From: Jean Fraser
To: Stowe, Barry
CC: Blais, Jason; Long, Steve; Margolis-Pineo, David; Trottier, Dave
Date: 4/22/2013 2:16 PM
Subject: RE: JB Brown, Commercial & Maple
Attachments: Revision Memo Marriott Portland 04-12-13.pdf; C13 Building Elevations MarriottPortland (Revisions) 04-12-13.pdf; C14 Building Elevations MarriottPortland (Revisions) 04-12-13.pdf; C05 Colored Revisions Plan Marriott Portland 04-12-13.pdf

From: Barry Stowe
To: Jean Fraser, Planner
Date: April 12, 2013
Subject: Commercial & Maple Street Mixed Use Development – Revisions

PROJECT: **COMMERCIAL & MAPLE STREET MIXED USE DEVELOPMENT** PORTLAND, ME

C05
 SHEET: 5 OF 14

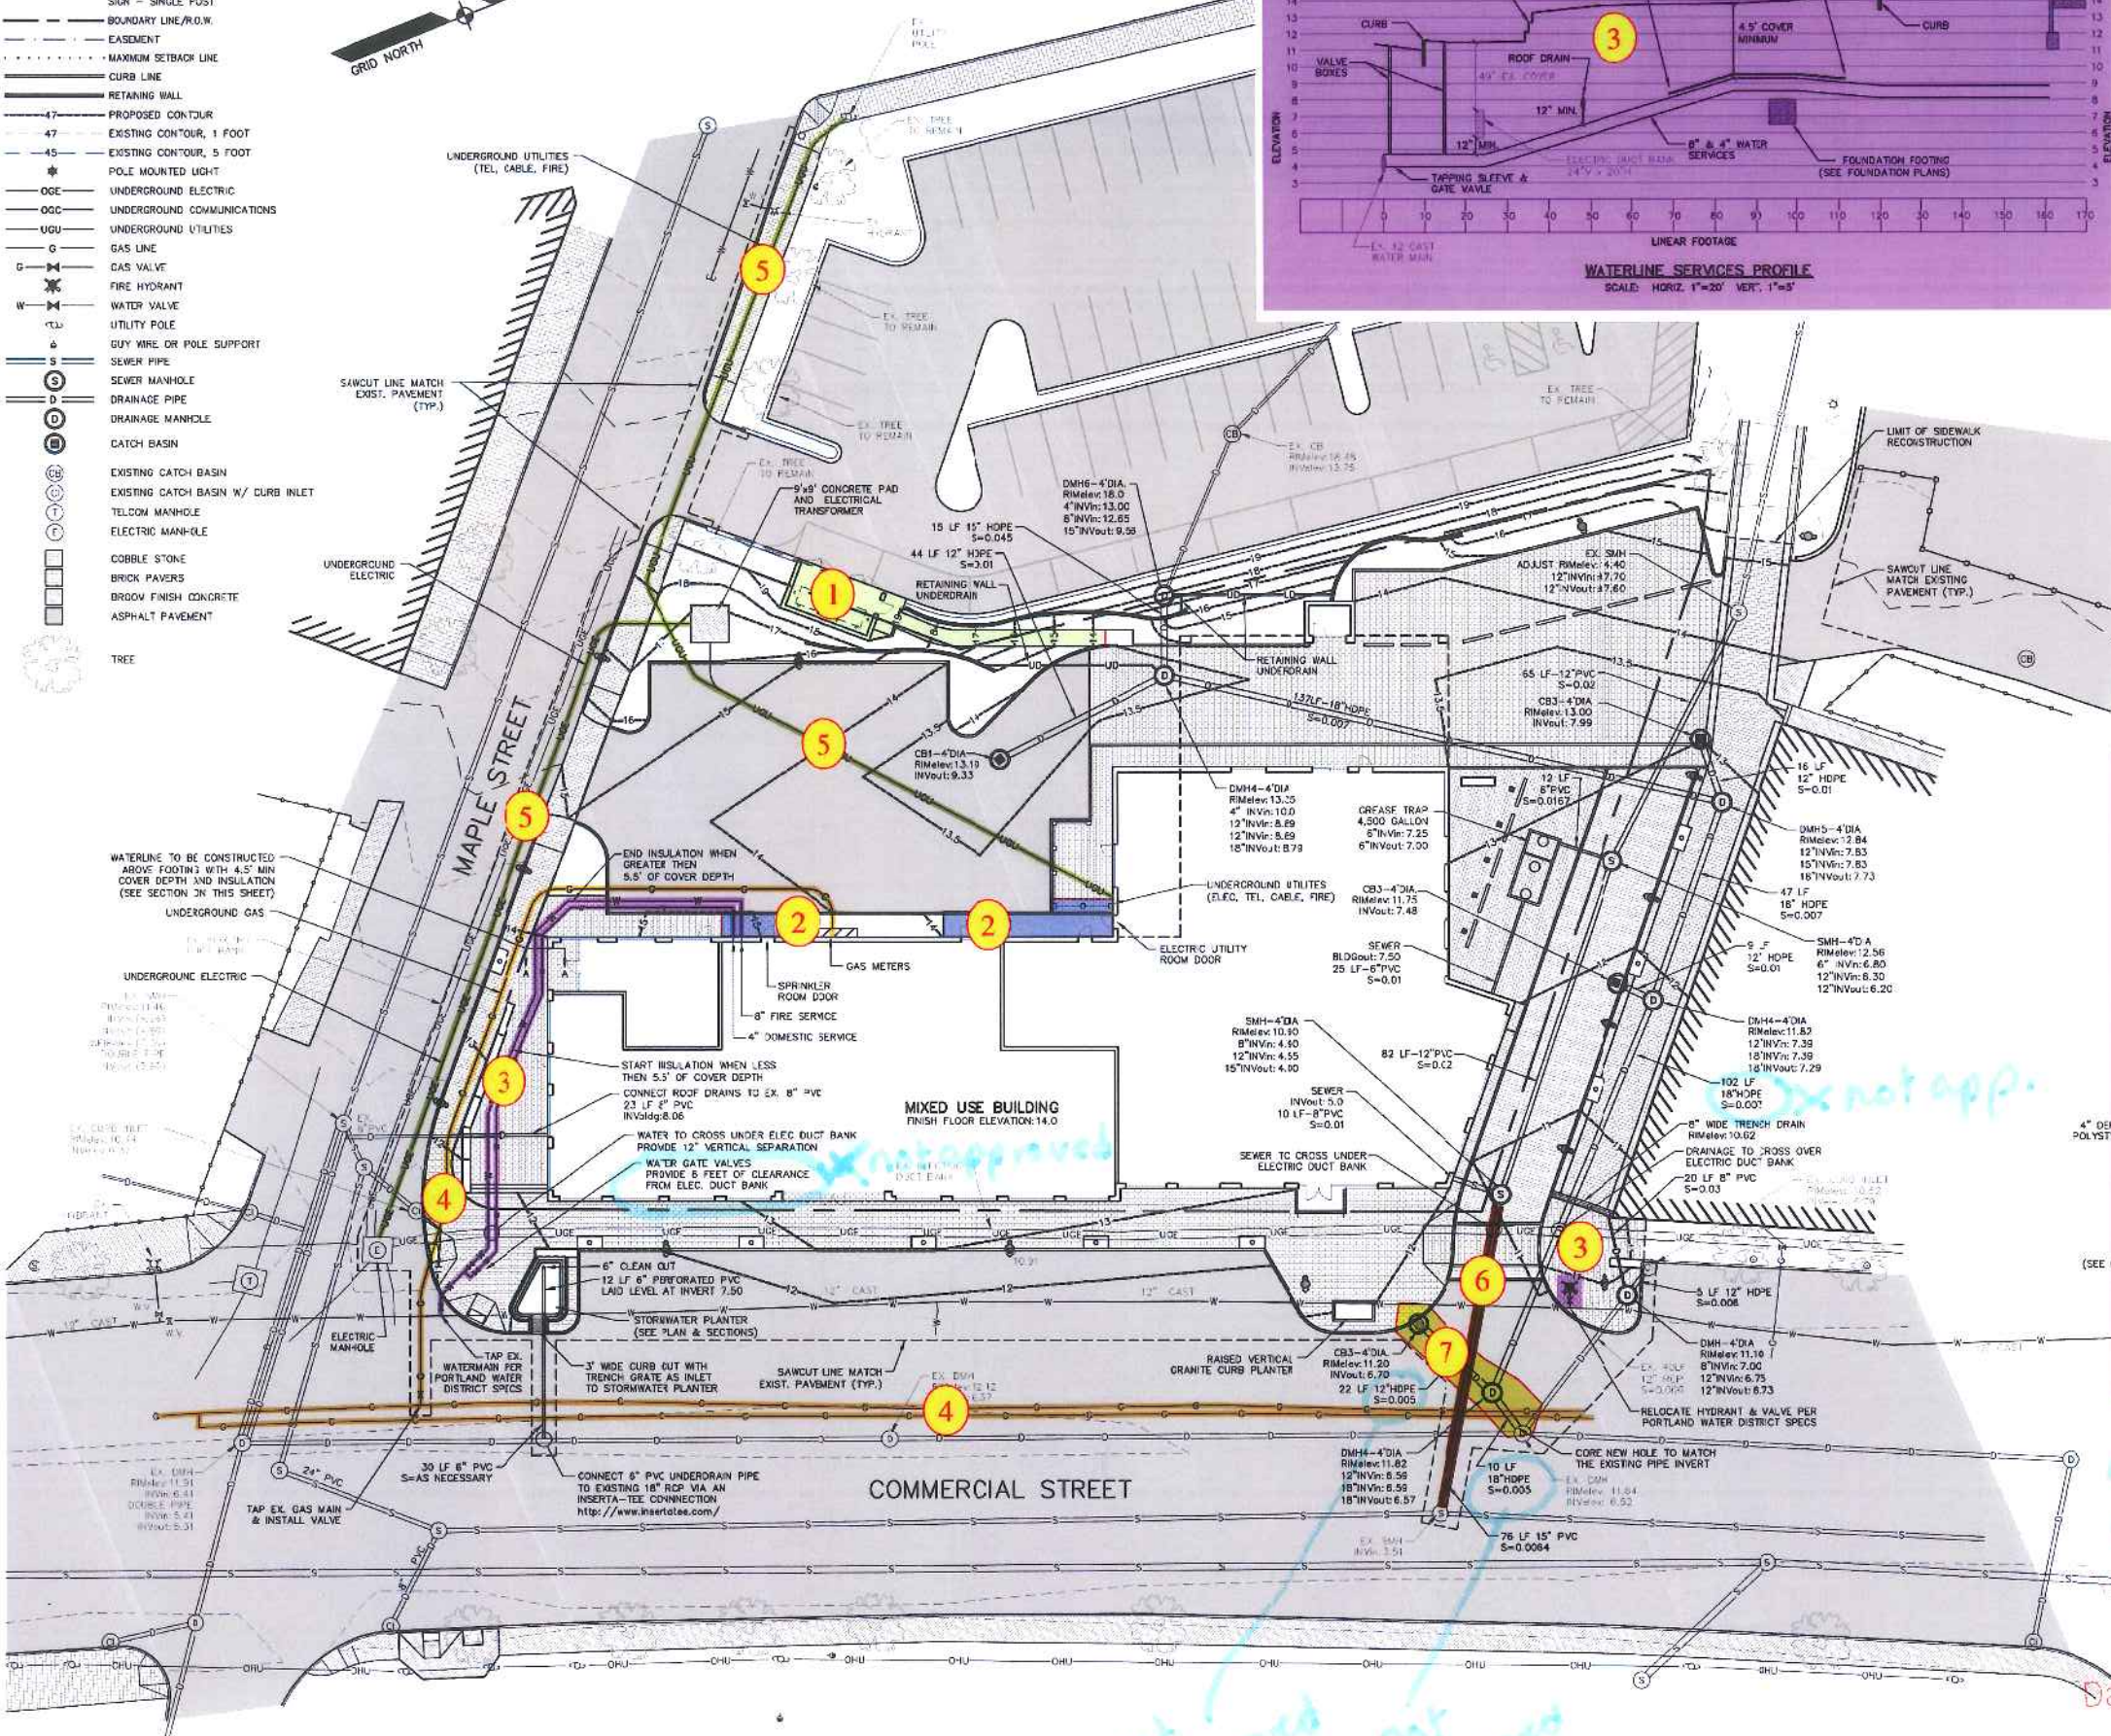
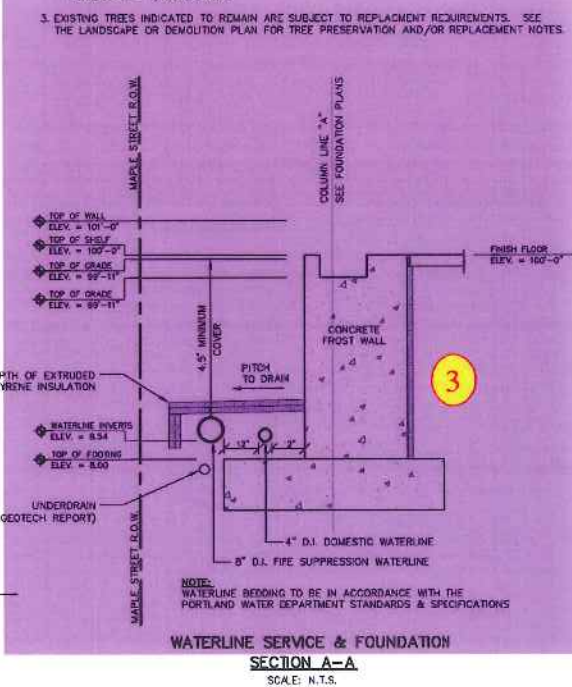
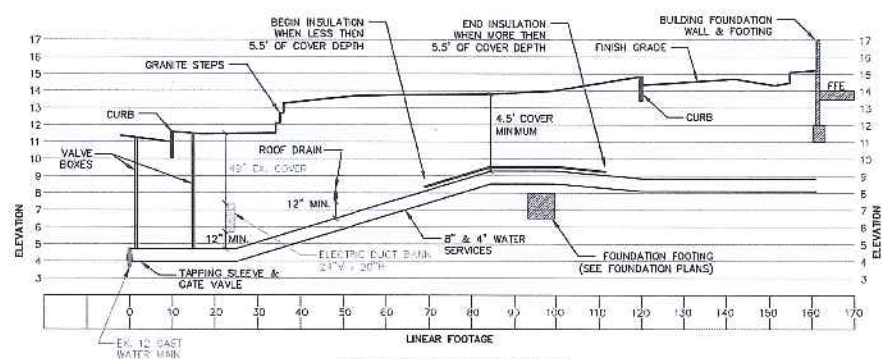
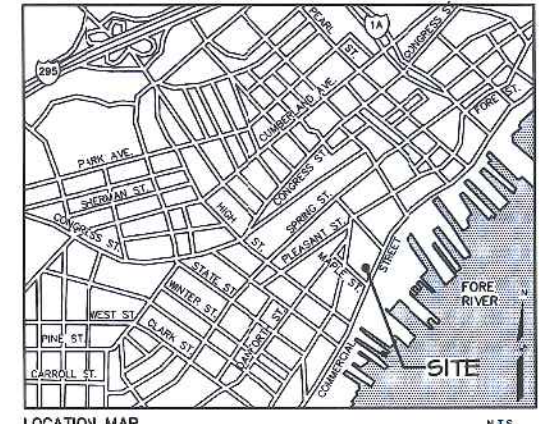
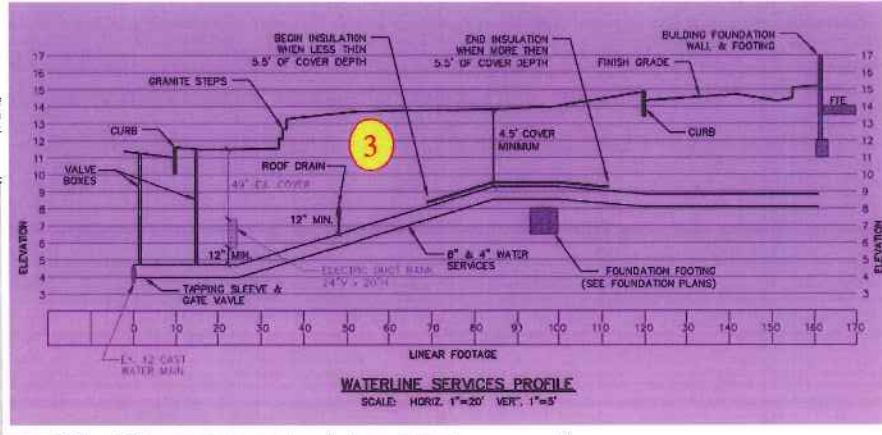
I am writing to confirm that the attached plans are approved subject to revision per your comments in the e-mail below. Please send (pdf OK) a revised CO5 with the pipe reference changed, and a note re ADA compliance of sidewalks added, and I will then stamp and circulate it to inspectors/records along with C13 and C14 to document the amendments.

1. (re 7 on your list) The proposed "HDPE" Drainage pipe for storm drain pipe connections within the City Right of Way is not an allowable pipe material in City streets (OK on your site). Anywhere that a storm drain pipe extends into the City Street, the pipe material will need to comply with the acceptable materials listed in Technical Manual 2.5.2.
Gorham Sand and Gravel is aware of the City requirements for pipe specifications and will be using the ADS N-12 HP meeting the minimum PS of 46. Attached are the pipe specifications. The pipe is a HDPE pipe so I will keep my plan labels the same. However, I'm going to add a note to the plan saying that all work within the ROW shall meet the City of Portland Technical Standards.

3. (Re 3 on your list) Re the water connection valves- what is shown is not the usual and I am waiting for some possible further comments from the Fire Dept on the hydrant relocation and water valves.

-  (1) The dumpster enclosure has been revised to be 3 feet longer. The approved enclosure size is 12 feet x 20 feet. This revision expands the enclosure size to 12 feet x 23 feet. As a result, it was necessary to reposition the enclosure to be in good alignment with the approach drive aisle. Also, the slope of the connecting sidewalk is increased slightly to accommodate the enclosure revisions.

-  (2) The sidewalks, patio and finish grades were revised to accommodate two new interior doors for the utility rooms. Revised building elevations showing the new doors are included.

-  (3) The waterlines services were revised per the request of the Portland Water District. The proposed water services now remain completely on the property and the gate valves have been move further away from the stormwater planter. In addition, a profile and section has been added to sheet C5 to assist PWD with their review.

Also, the proposed fire hydrant has been moved to a different location. The Portland Water District requested greater horizontal clearance from the tree planter.

-  (4) It was realized that the previously shown existing gas main in Commercial Street is abandoned. The correct gas main is now shown on the plans. Accordingly, the gas service to the proposed building was revised.

-  (5) The Owner has decided to remove the existing utility pole on Maple Street. As a result, the electric services will be installed from the manhole located at the intersection of Commercial and Maple Streets. Also, communications services will continue to be provided from the existing utility pole at the intersection of York and Maple Streets. However, the communication services will be installed entirely underground.

-  (6) As a result of the gas main location, it was necessary to revise the proposed sewer main at the intersection of Foundry Lane and Commercial Street. The proposed sewer manhole was deleted and the proposed sewer pipe will now be constructed the existing manhole in Commercial Street.

-  (7) As a result of the gas main location, it was necessary to revise the proposed drainage at the intersection of Foundry Lane with Commercial Street. The drainage manhole was moved to accommodate the gas line. In addition, the Portland Water District request that the catch basin be moved slightly to provide greater clearance from the waterline.

for the record, I confirm that the proposed changes re the water mains (as you have shown) have been reviewed by the Fire Dept and DPS and are acceptable. I also confirm that Deb Andrews has approved the revised utility door locations (as shown) in the context of the HP approval.

2. (re 2 on your list) We would like to have confirmation that the finished grades etc are ADA compliant.
Yes, all the grading around the accessible parking remains ADA compliant. Please see the attached sheet C6.

DATE: 10-22-12
SCALE: 1"=20'
DRAWN BY: BUS
C05
SHEET: 5 OF 14

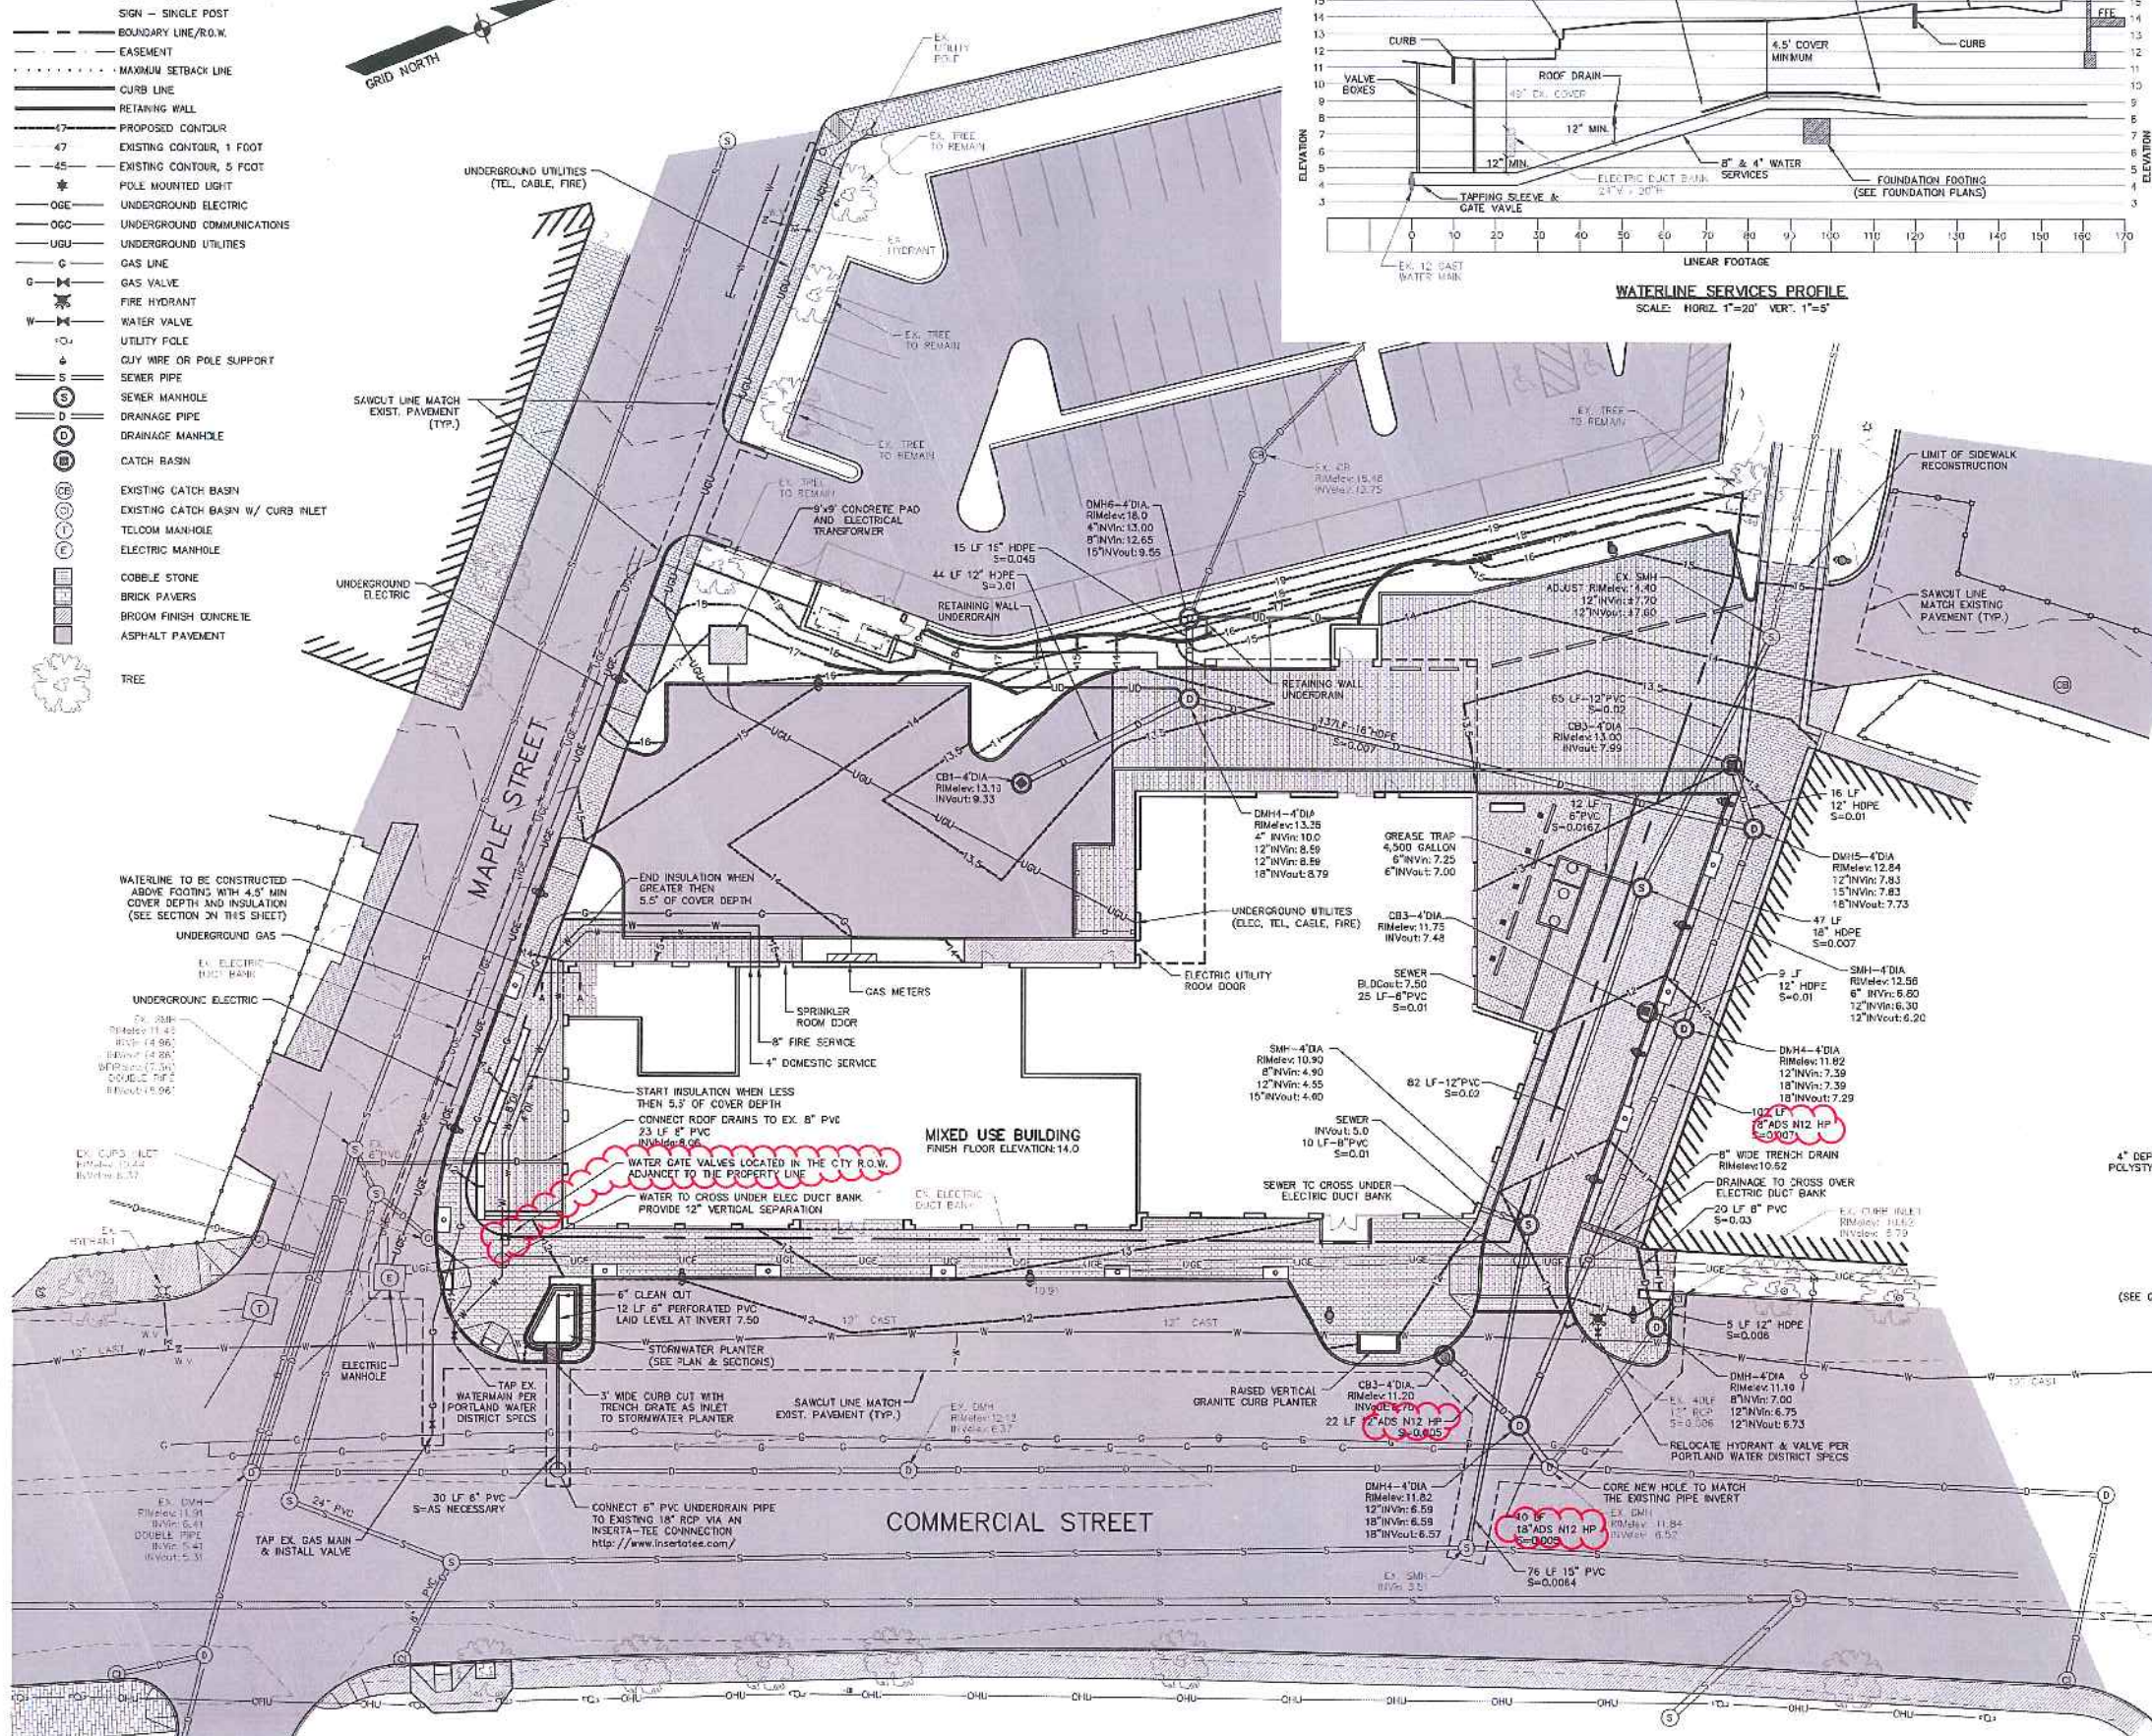
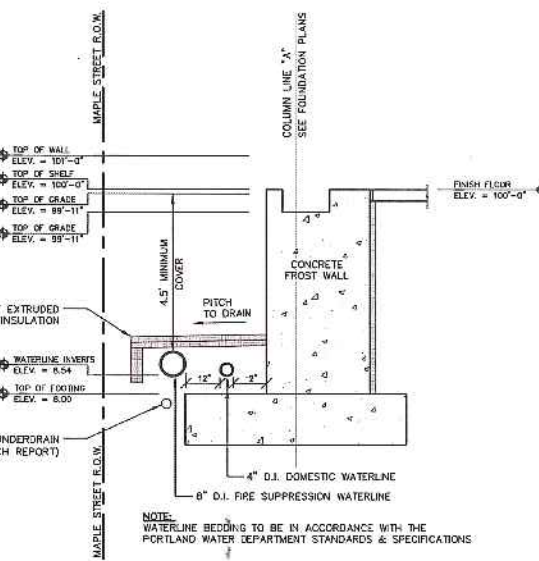
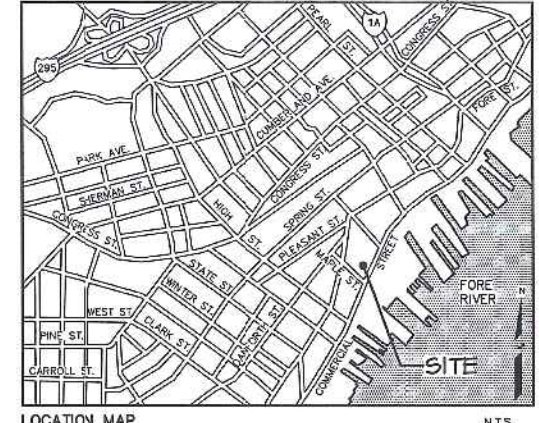
WATERLINE SERVICE & FOUNDATION SECTION A-A
CITY OF PORTLAND
APPROVED SITE PLAN
Subject to Dept. Conditions
Date of Approval: 1-22-2013
amended 4-23-2013
clouded changes

DATE	REVISION	DESCRIPTION
08-04-09	01	MOVED ELECTRIC UTILITY ROOM AND REVISED ELECTRIC & COMM CONDUIT
04-12-10	02	REVISED GAS, WATER, DRAINAGE SEWER AND THE DUMPSTER ENCLOSURE
04-28-10	03	REVISED GAS, WATER, DRAINAGE SEWER AND THE DUMPSTER ENCLOSURE
04-28-10	04	REVISED WATER SERVICE VALVE LOCATIONS TO THE PROPERTY LINE
